BEFORE THE SOUTH DAKOTA PUBLIC UTILITIES COMMISSION

DOCKET NO. HP07-001

IN THE MATTER OF THE APPLICATION OF TRANSCANADA KEYSTONE PIPELINE, LP
FOR A PERMIT UNDER THE SOUTH DAKOTA ENERGY CONVERSION AND
TRANSMISSION FACILITY ACT TO CONSTRUCT THE KEYSTONE PIPELINE PROJECT

Surrebuttal Testimony of William Walsh on Behalf of the
Staff of the South Dakota Public Utilities Commission

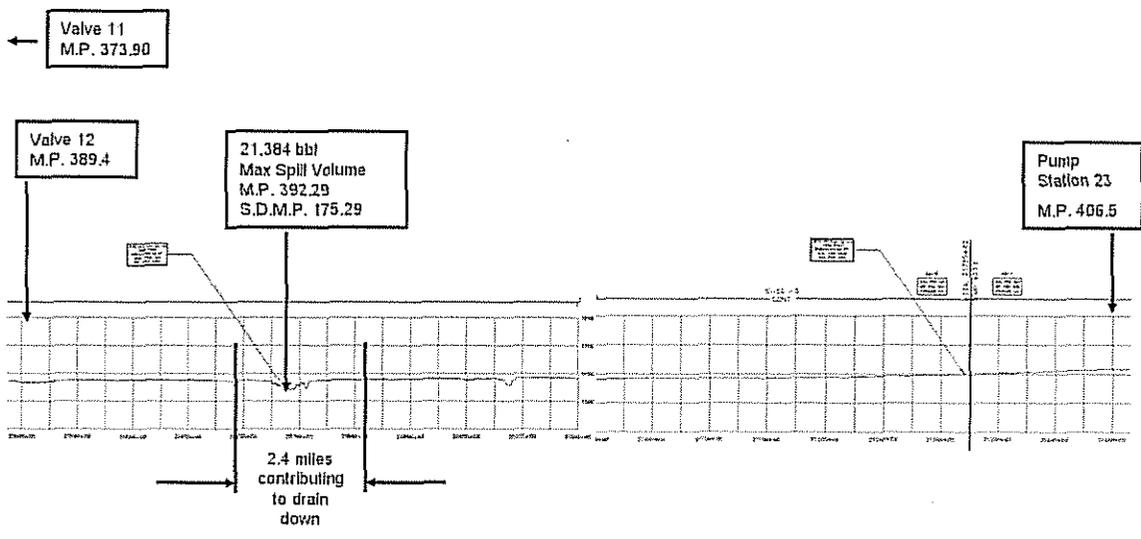
10
11 Mr. Thomas indicates that the leak model has been revised from that presented in
12 the 'Frequency- Volume Study' submitted with the initial siting application. The
13 model still consists of a dynamic phase and a static phase. The dynamic phase
14 refers to the period of the release prior to pump shutdown and valve closure. The
15 static phase accounts for the draining of the product after isolation.

16
17 The dynamic phase leak rate is determined by the pressure at the leak site based
18 on the hydraulic profile and the corresponding pipeline flow rate. The maximum
19 leak rate is equal to the flow rate – the pipeline can not leak more product than is
20 flowing through the pipe. At locations on the pipeline where the pressure is
21 below approximately 70 psi (near the suction side of a pumping station), the leak
22 rate is determined by the orifice equation and may be lower than the flow rate.

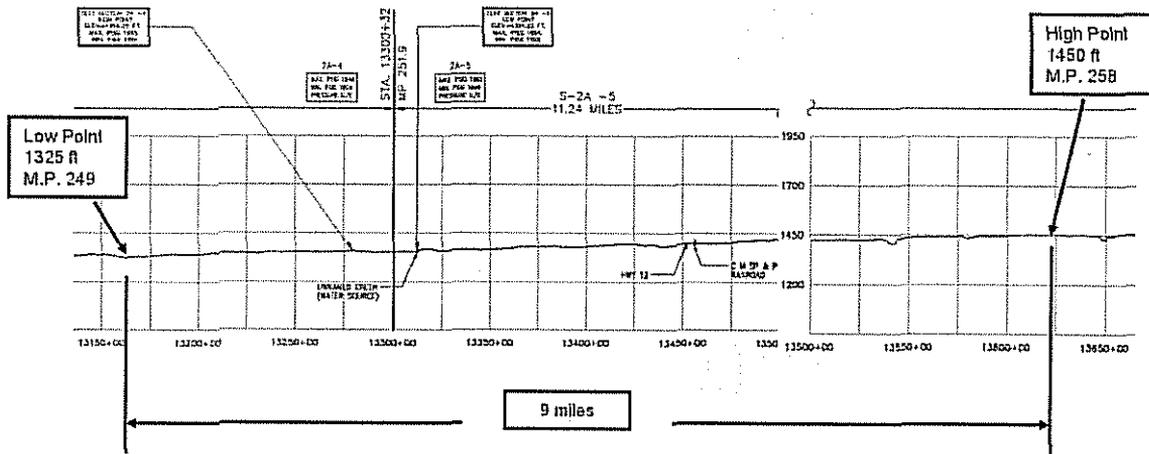
5
6 The amount of product escaping during the static phase is based on the volume
7 between valve locations. All the volume is allowed to escape except that volume
8 trapped due to the elevation profile. In the example, of the 41.4 miles between
9 Pump Station 23 (M.P. 406.5 – total pipeline) and isolation valve 11 (M.P. 373.90
10 – total pipeline), all but 2.4 miles are trapped due to the elevation profile. This
11 converts into a volume of 12,765 barrels released during the static phase from
12 drain down. The total spill volume is estimated as 21,384 barrels - 8,619 barrels
13 during the dynamic phase and 12,765 barrels during the static phase. The figure
14 below illustrates the situation on the hydraulic profile sheet provided by Keystone
15 in response to Data Request 6-35.

The figure assumes that South Dakota M.P 1 used in Mr. Thomas’s rebuttal is equal to M.P. 217 based on the total pipeline. The example location South Dakota M. P. 175.29 would correspond to pipeline M.P. 392.29. If the mile post number conversion is correct, the pipeline segment lies between Valve 12 at M.P. 389.4 and pump station 23 at M. P. 406.5 as shown above.

The rebuttal testimony of Mr. Thomas includes a plot showing the maximum calculated spill volume along the pipeline in South Dakota assuming a pipeline flow rate of 591,000 barrels per day. The maximum spill volume corresponds to the example location above (South Dakota M.P. 175.29) of 21,384 barrels.

The example illustrates the following:

- At pipeline locations where no static phase discharge volume is expected, the maximum spill volume is the dynamic phase release volume of 8,619 barrels. This would correspond to locations at high local elevations. The plot of maximum calculated spill volume shows that this value is the minimum volume expected.
- The maximum estimated spill volume results from a static phase (drain down) release of 2.4 pipeline miles of product. This is the estimated maximum at any point along the pipeline in South Dakota.
